**AMENDMENT TO THE DRAWINGS**

Appl. No. 09/526,100  
Amdt. Dated Oct. 15, 2003  
Reply to Office action of July 16, 2003  
Replacement Sheet

FIG. 7

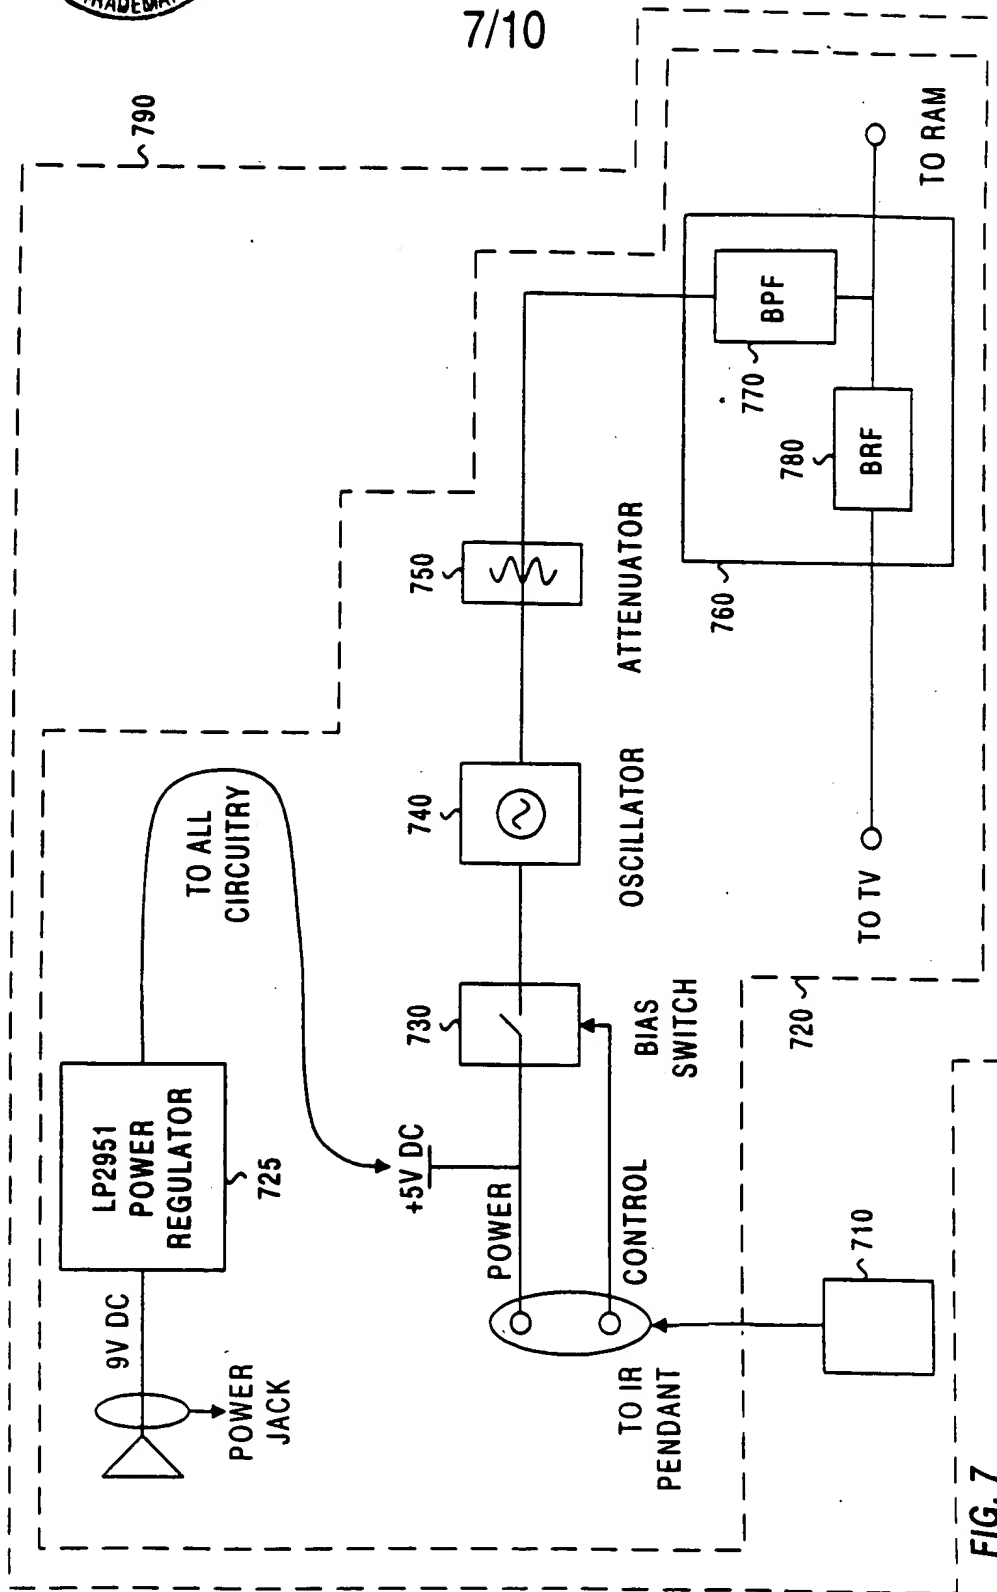
The attached sheet of drawings includes changes to FIG. 7, and replaces the original sheet including FIG. 7. In FIG. 7, the direction of the signal communication between infrared receiver 710 and the element marked "To IR Pendant" is corrected, as required by the Examiner.
